Subject: New blown fuse indicator design change for FLNR 35-400 Amp Fuses.

Document#LFPCN_PG0023

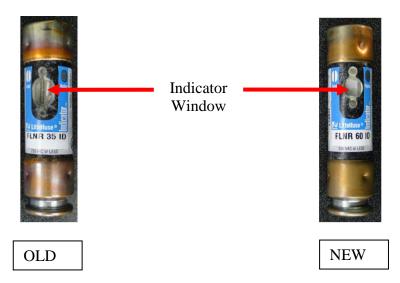
This letter is to inform Littelfuse Sales, Sales Support & Customers of a design change to the fuse status indicator feature for Series FLNR 35 thru 400 amp ratings.

There will be a slight visual change to the components behind the indicator window, but the indicator functionality will remain the same. When a fault occurs the indicator window will turn black from its operational (no-fault) color, white.
